SUSQUEHANNA STEAM ELECTRIC STATION, UNIT 1

AMENDMENT TO FACILITY OPERATING LICENSE

Amendment No. 64
License No. NPF-14

ENCLOSURE TO LICENSE AMENDMENT NO. 64

MAXIMUM AVERAGE PLANAR LINEAR HEAT GENERATION RATE (MAPLHGR) VERSUS AVERAGE PLANAR EXPOSURE
GE FUEL TYPES 8CR233 (2.33% ENRICHED)
FIGURE 3.2.1-1

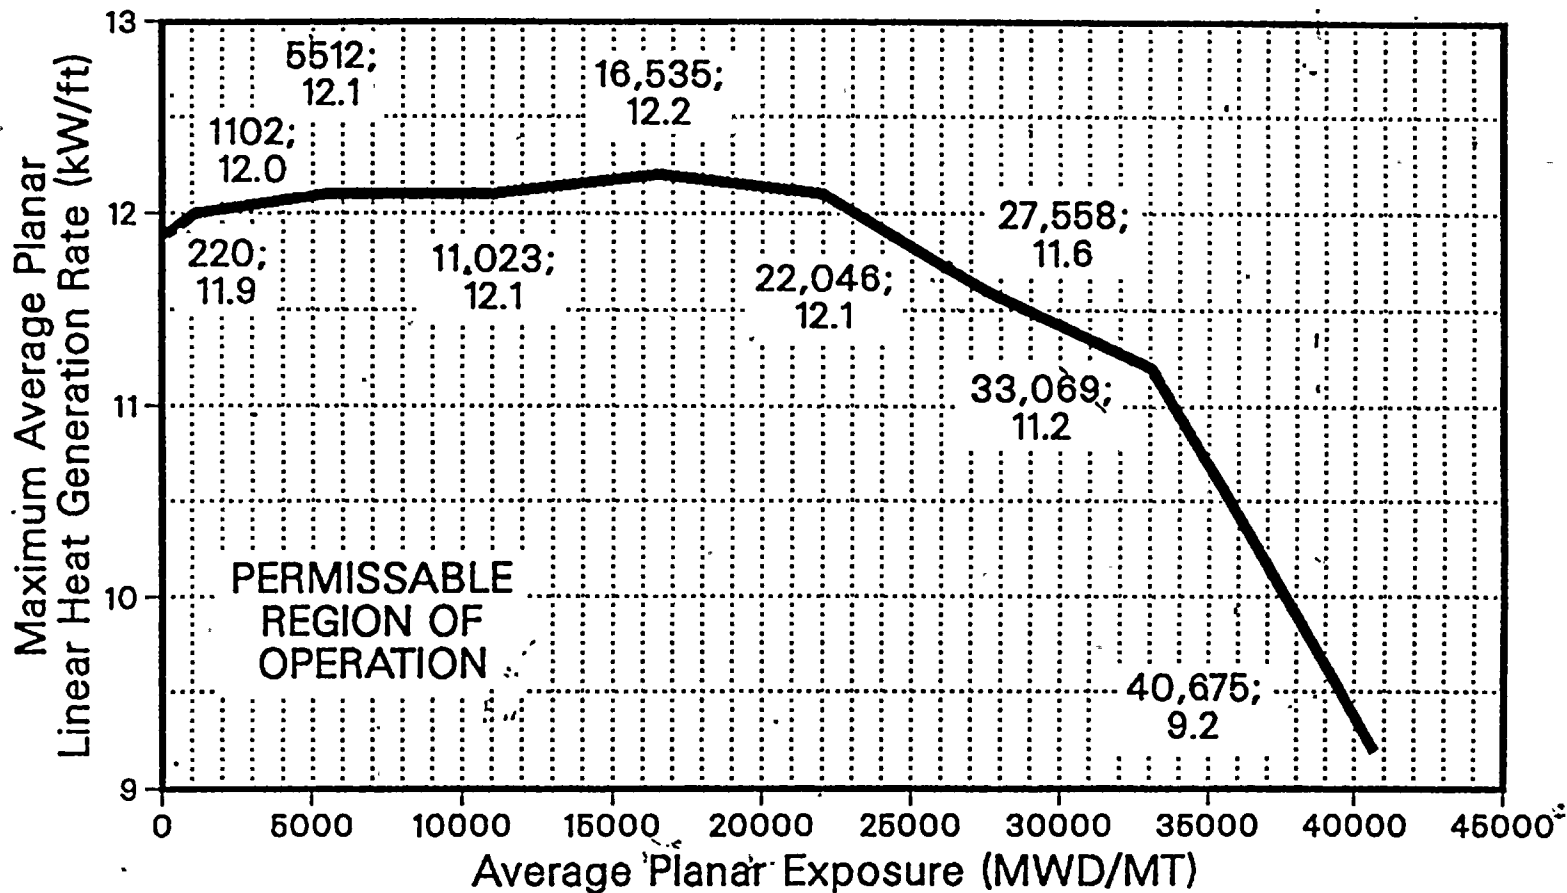
3.2.1-1	MAXIMUM AVERAGE PLANAR LINEAR HEAT GENERATION RATE (MAPLHGR) VS. AVERAGE PLANAR EXPOSURE, GE FUEL TYPE 8CR233 (2.33% ENRICHED).....	3/4 2-3
3.2.1-2	MAXIMUM AVERAGE PLANAR LINEAR HEAT GENERATION RATE (MAPLHGR) VS. AVERAGE BUNDLE EXPOSURE, EXXON 8x8 FUEL.....	3/4 2-4

3. Specification 3.2.1: The MAPLHGR limits shall be as follows:

- a. GE fuel: the limits specified in Figure 3.2.1-1 multiplied by 0.81.
- b. Exxon fuel: the limits specified in Figure 3.2.1-2 multiplied by 0.0.

MAXIMUM AVERAGE PLANAR LINEAR HEAT GENERATION RATE (MAPLHGR) VERSUS AVERAGE BUNDLE EXPOSURE EXXON 8X8 FUEL
FIGURE 3.2.1-2

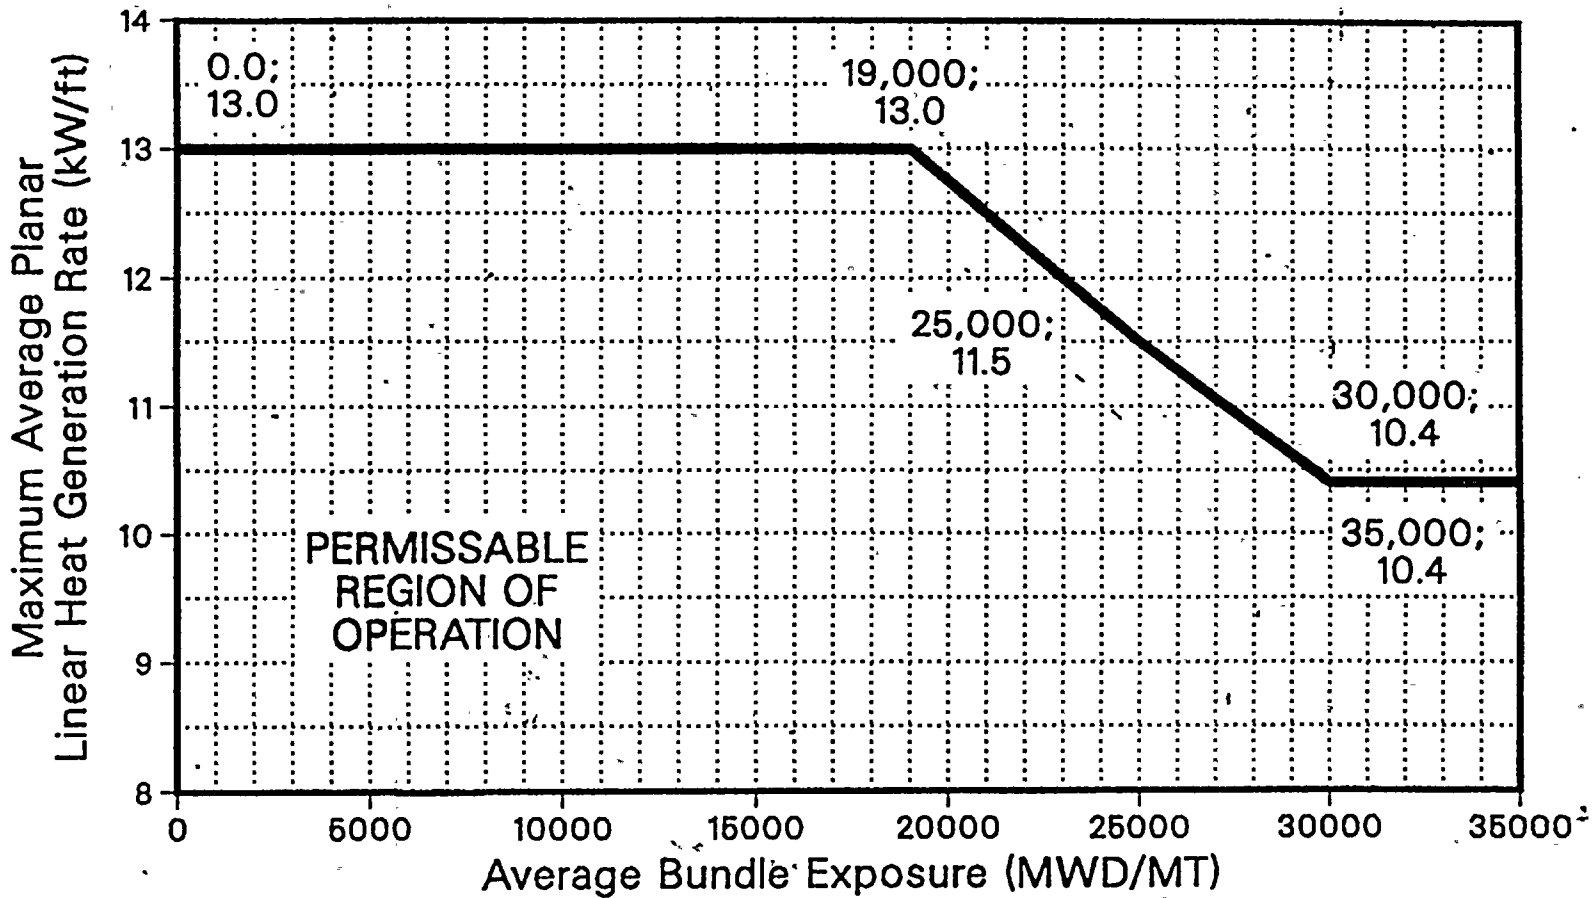
For single loop operation, the MAPLHGR limits for Exxon fuel are multiplied by a factor of 0.0. This multiplication factor precludes extended operation with one loop out of service.

**FLOW DEPENDENT MCPR OPERATING LIMIT
FIGURE 3.2.3-1**

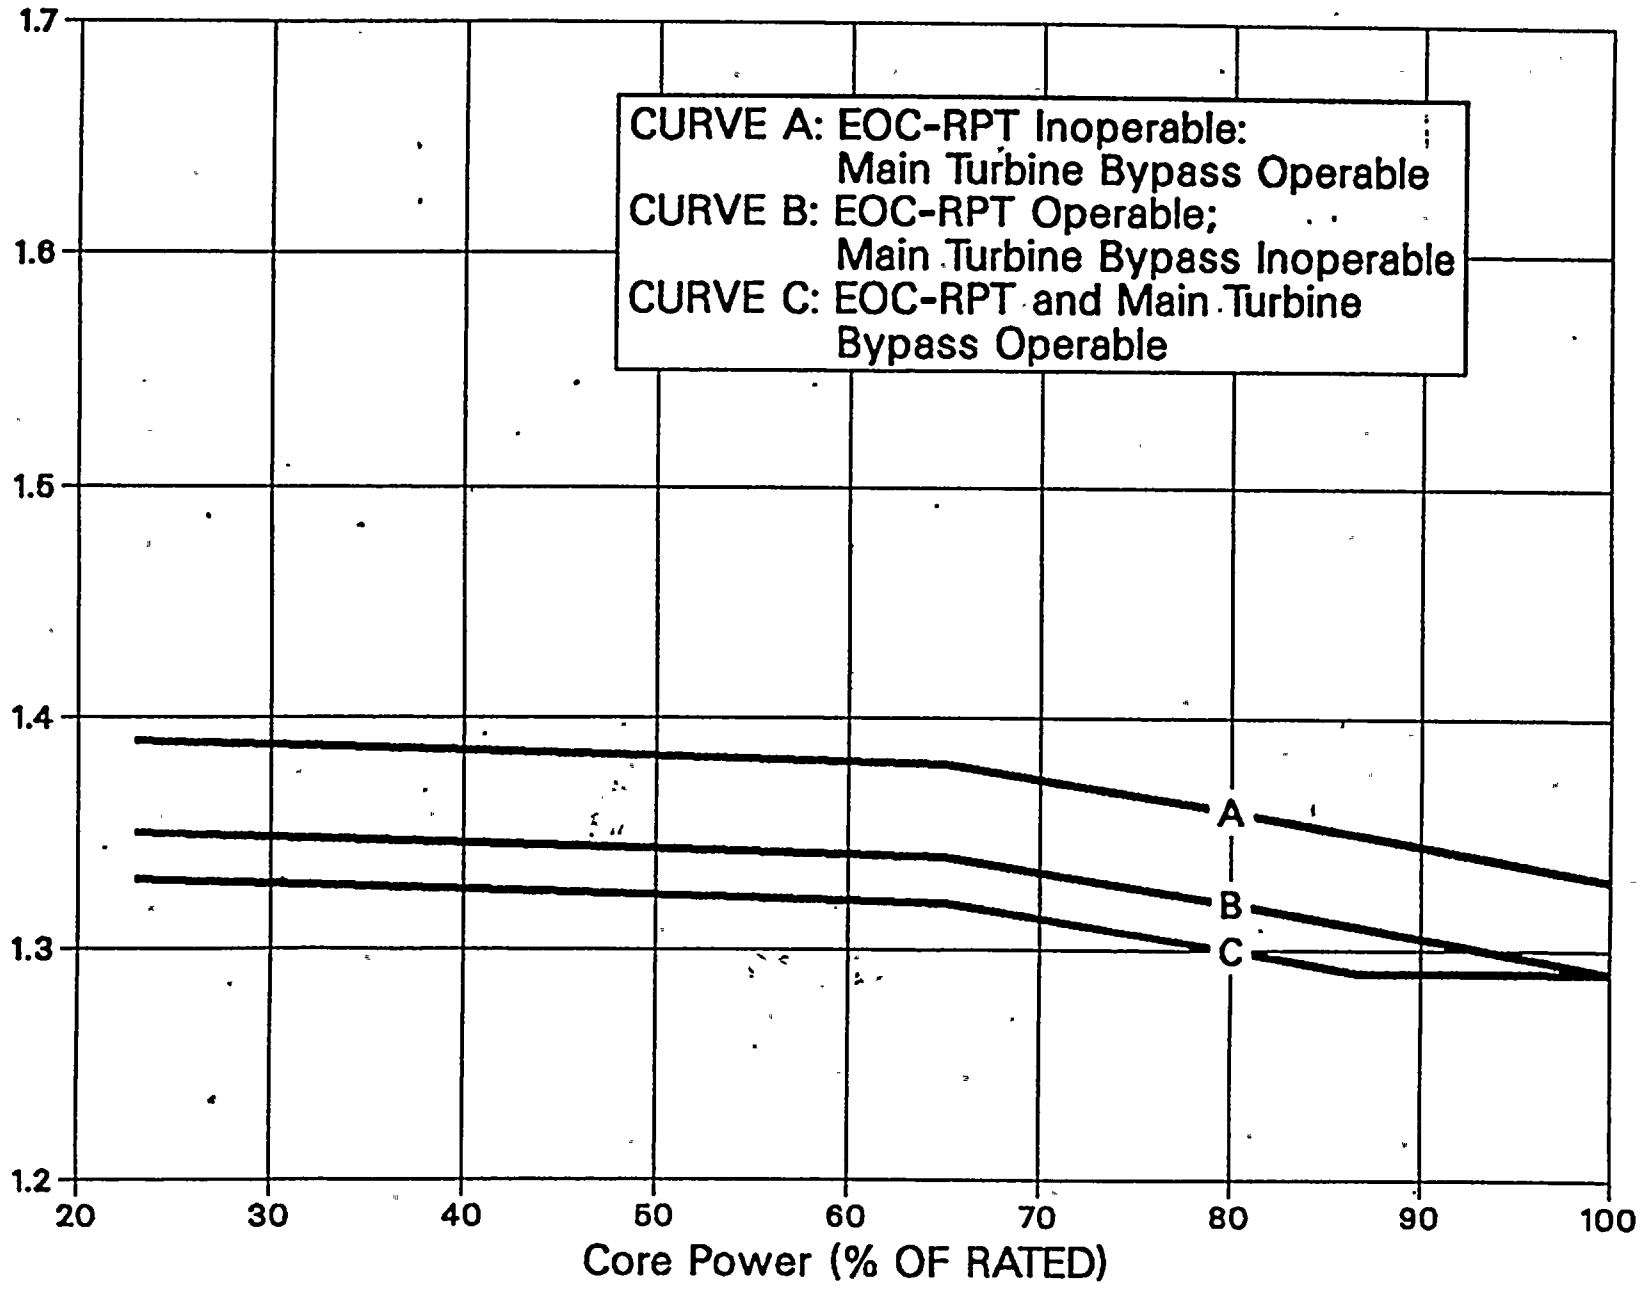
3.2.3 The MINIMUM CRITICAL POWER RATIO (MCPR) shall be greater than or equal to the greater of the two values determined from Figure 3.2.3-1 and Figure 3.2.3-2

4.2.3.1 MCPR shall be determined to be greater than or equal to the applicable MCPR limit determined from Figure 3.2.3-1 and Figure 3.2.3-2:

Figure 3.2.3-1 defines core flow dependent MCPR operating limits which assure that the Safety Limit MCPR will not be exceeded during a flow increase transient resulting from a motor-generator speed control failure. The flow dependent MCPR is only calculated for the manual flow control mode. Therefore, automatic flow control operation is not permitted. Figure 3.2.3-2 defines the power dependent MCPR operating limit which assures that the Safety Limit MCPR will not be exceeded in the event of a feedwater controller failure initiated from a reduced power condition.

Figure 3.4.1.1.1-1
THERMAL POWER LIMITATIONS

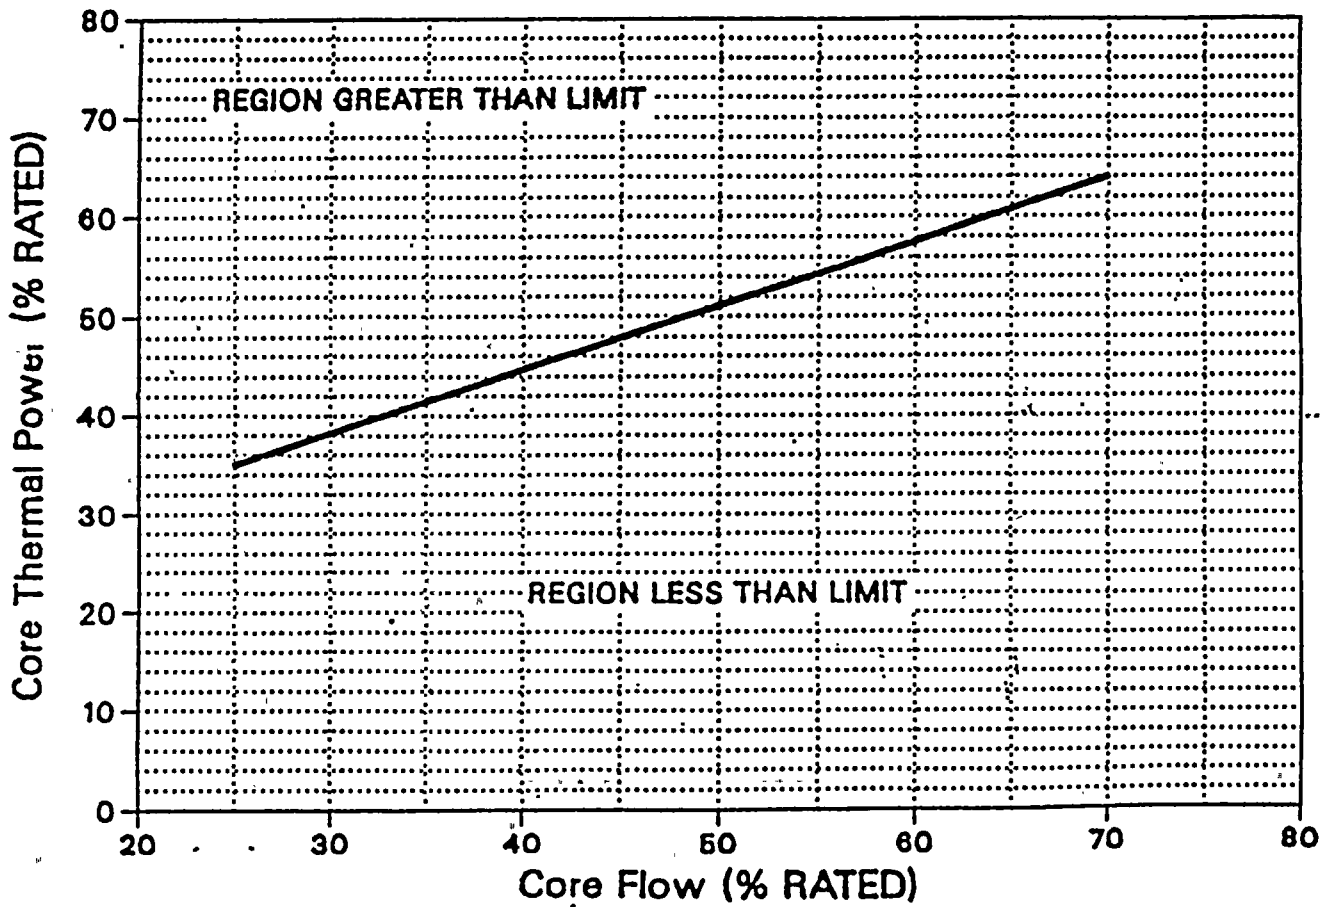
b. APRM and LPRM*** neutron flux noise levels shall be less than three times their established baseline levels when THERMAL POWER is greater than the limit specified in Figure 3/4.1.1.1-1.

c. Total core flow shall be greater than or equal to 42 million lbs/hr when THERMAL POWER is greater than the limit specified in Figure 3.4.1.1.1-1.
